STAFF RECOMMENDATION 1808 Lillian Street February 20, 2019

Application: Demolition-Partial; New Construction—Addition and Outbuilding
District: Lockeland Springs-East End Neighborhood Conservation Zoning Overlay
Council District: 06
Map and Parcel Number: 08314026900
Applicant: Christopher Milfred, Third Coast Real Estate.
Project Lead: Melissa Baldock, melissa.baldock@nashville.gov

<p>Description of Project: Application is to construct a rear addition and an outbuilding. The outbuilding will not be used as a DADU.</p> <p>Recommendation Summary: Staff recommends approval of the project with the following conditions:</p> <ol style="list-style-type: none">1. Staff approve the final details, dimensions and materials of windows and doors prior to purchase and installation;2. The siding reveal on the addition and the outbuilding have a maximum reveal of five inches (5");3. There be a minimum distance of twenty feet (20') between the back of the house/addition and the garage;4. Staff approve the roof color and shingle of the addition and outbuilding; and5. Staff approve the HVAC location. <p>With these conditions, staff finds that the proposed addition and outbuilding meet Section II.B

SITE PLAN

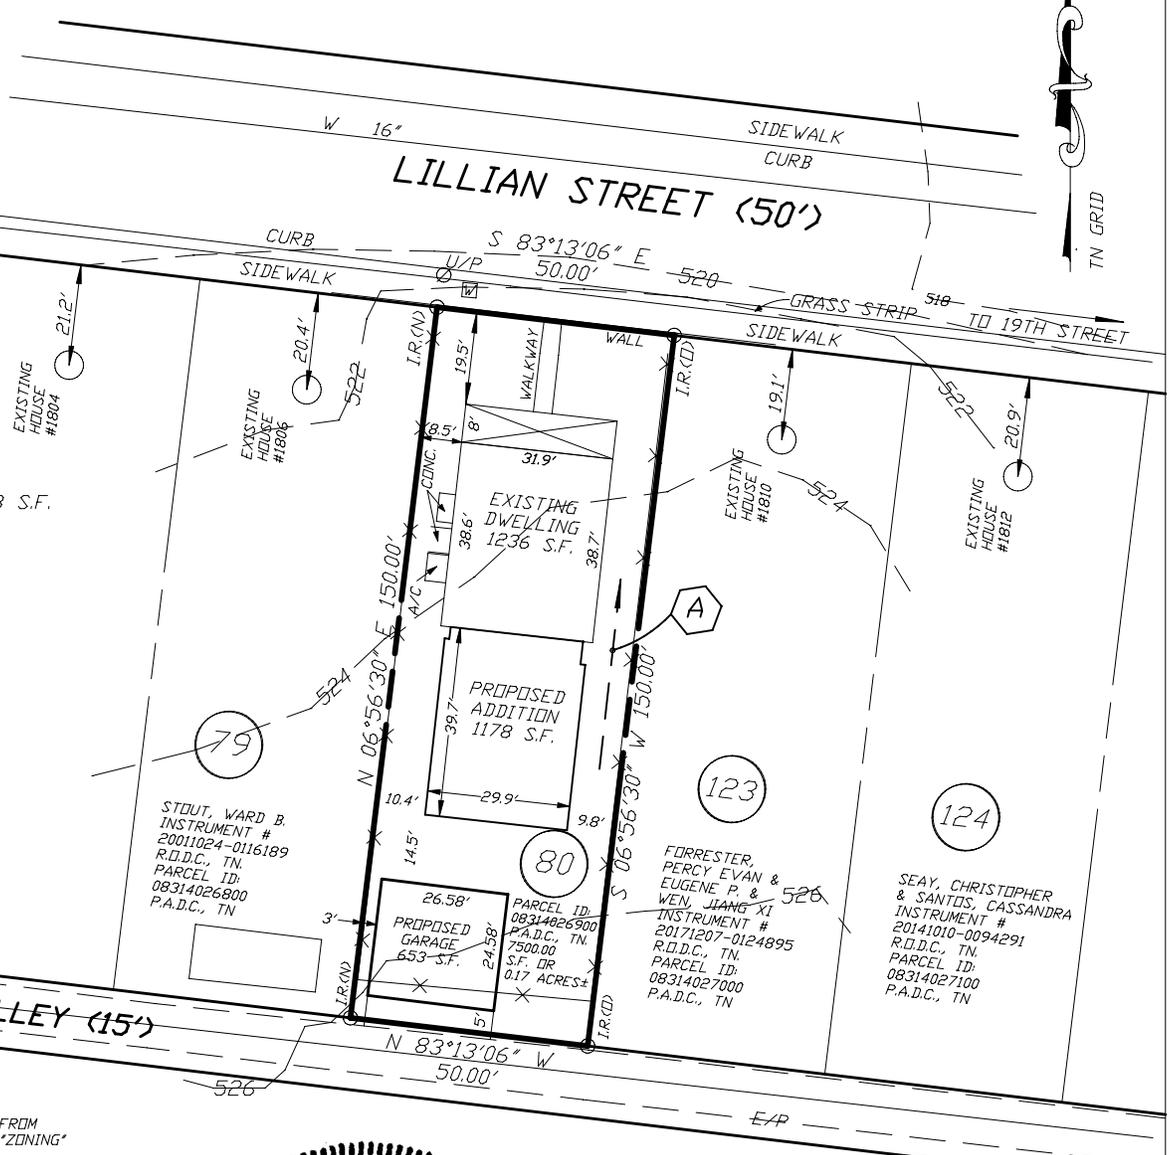
MINIMUM	PROPOSED
Space between principal building and DADU/Garage	20'	14'6''*
Rear setback	5'	5'
L side setback**	3'	21'
R side setback**	3'	3'
How is the building accessed?	From the alley or existing curb cut	Alley

* The design guidelines require a distance of twenty feet (20') between the back of the house/addition and any outbuilding. The applicant is proposing a distance of just fourteen feet, six inches (14'6"). The Commission has reduced the twenty-foot (20') requirement only in cases where there are unusual lot constraints, like an unusually deep front setback, an unusually shallow or shaped lot, extreme slope change, or easements. Staff could not find any unusual constraints on this lot or any reason why the applicant should not be required to meet the twenty foot (20') distance between the back of the house/addition and the garage. Staff therefore recommends that the addition and garage be reconfigured so that there is a minimum distance of twenty feet (20') between the two structures.

With the condition that there be a minimum of twenty feet (20') between the back of the addition and the garage, staff finds that the addition's height and scale meet Sections II.B.1., II.B.2., and II.B.10 of the design guidelines

LEFT ELEVATION

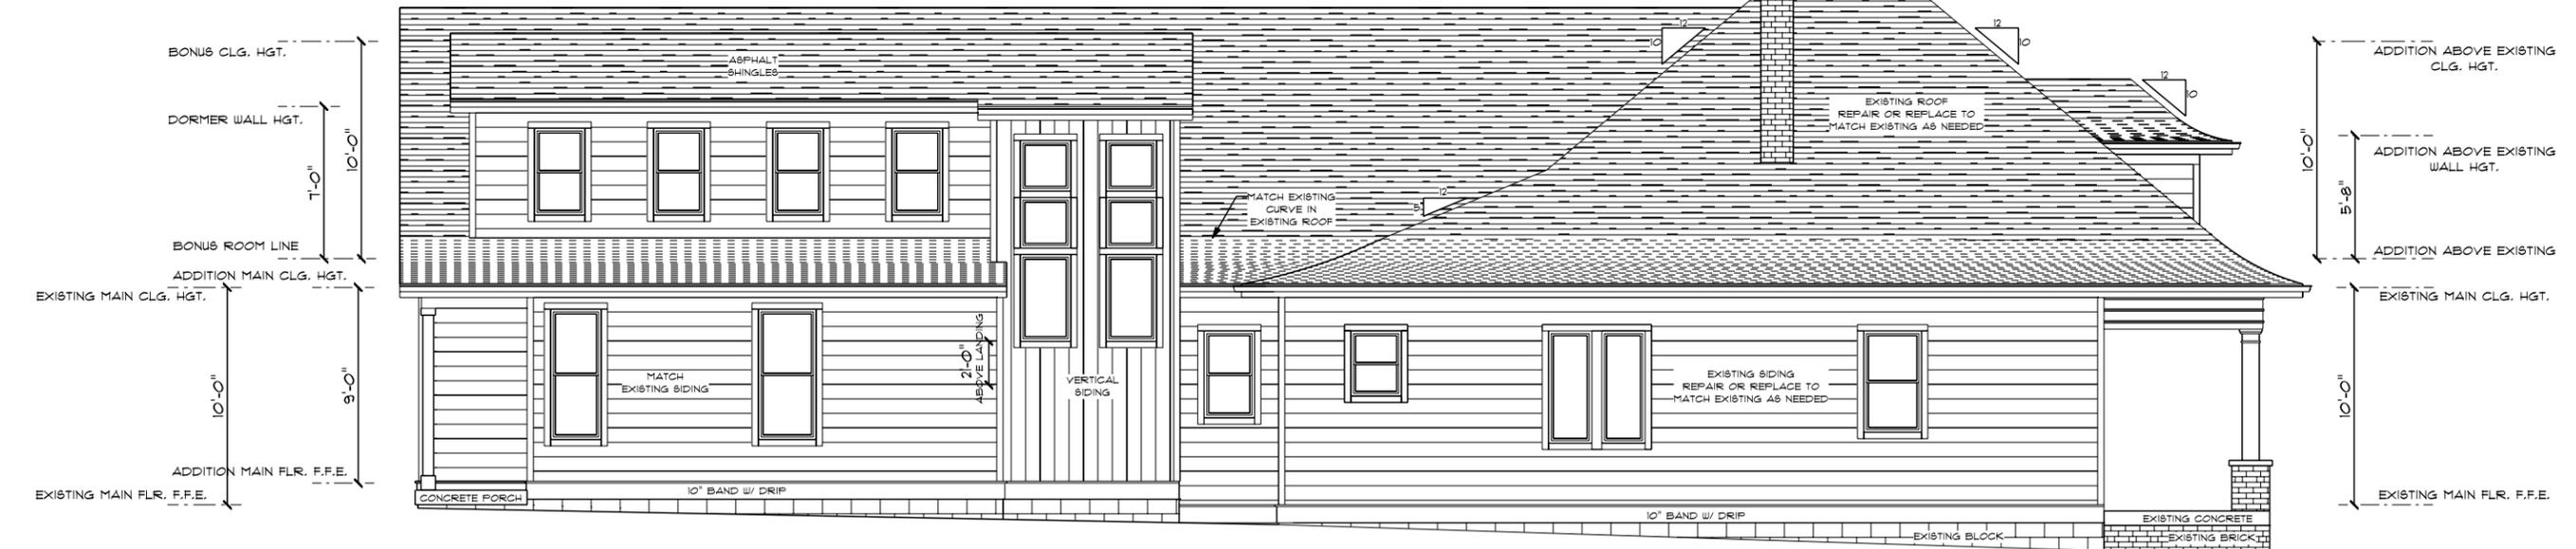
Demolition—Partial: The applicant is proposing to remove a window opening on the right façade. This is considered partial demolition. The window is all the way at the back of the historic house, under a shed roof form that is different from the main hip roof of the house (Figure 2). Staff finds that the removal of this window opening is acceptable because it is located all the way at the back of the house and is not highly visible from the street. On the left façade, the applicant intends to keep the window closest to the front of the house, but remove the paired windows towards the back (Figure 3). The window opening will remain the same size, but casement windows will be installed in order to provide egress to the bedroom. In a conservation zoning overlay like Lockeland Springs, MHZC does not review the replacement of windows and therefore will not review this change. However, staff and the applicant will work together to see if there is a way to preserve the existing windows and meet the egress requirements. Also on the left façade, at the very back of the house, the applicant intends to retain the existing wood window

but move it further towards the front of the house by about eighteen inches (18"). Staff finds this to be appropriate since both the window and the opening size will remain as it is now and this change is at the back of the house.

Figure 3. The paired window opening will remain the same size, but the existing double hung windows will be replaced with casement windows. The window at the back will be moved towards the front of the house by about 18".

Staff finds the proposed alterations to the window openings on the side facades to meet Section III.B.2 for appropriate demolition.

MAIN FLOOR PLANS

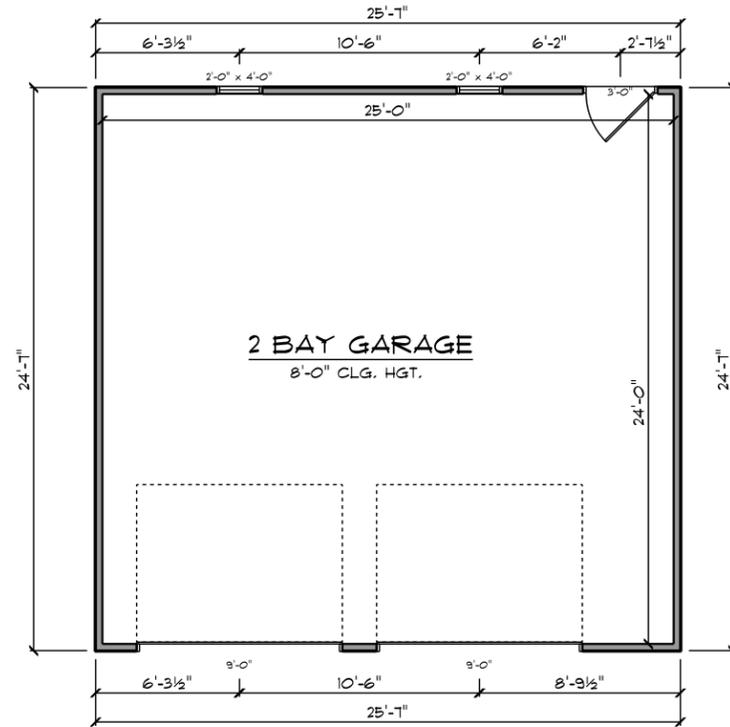
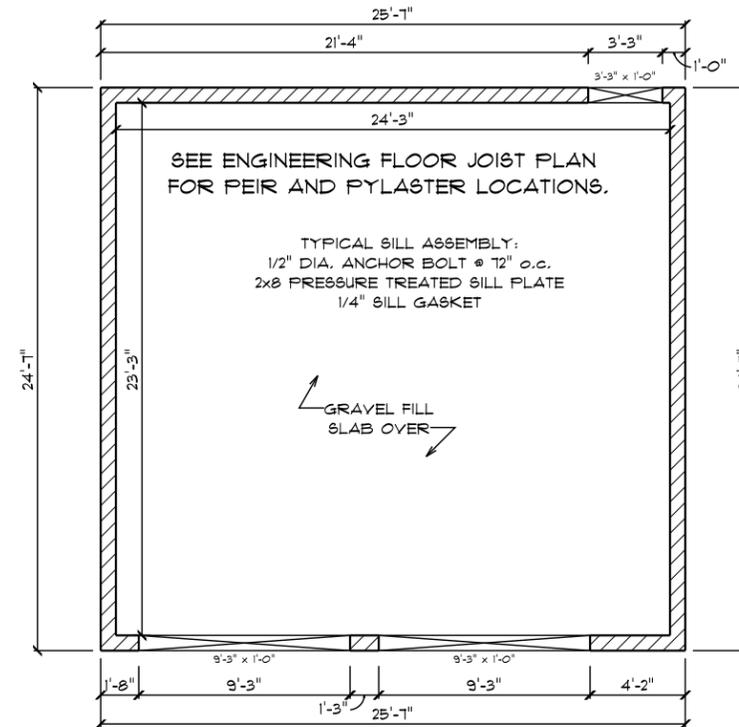
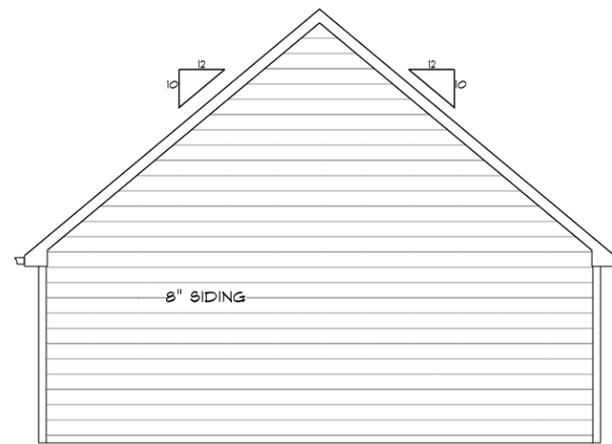
*The drawings call for eight inch (8") lap siding, but the design guidelines restrict the siding reveal to five inches (5'). Staff therefore recommends that the garage's siding have a maximum reveal of five inches (5').

With the condition that the siding reveal be five inches (5") or less, and with staff's final approval of the roof shingle color and all windows and doors, staff finds that the known materials meet Section II.B.8. of the design guidelines.
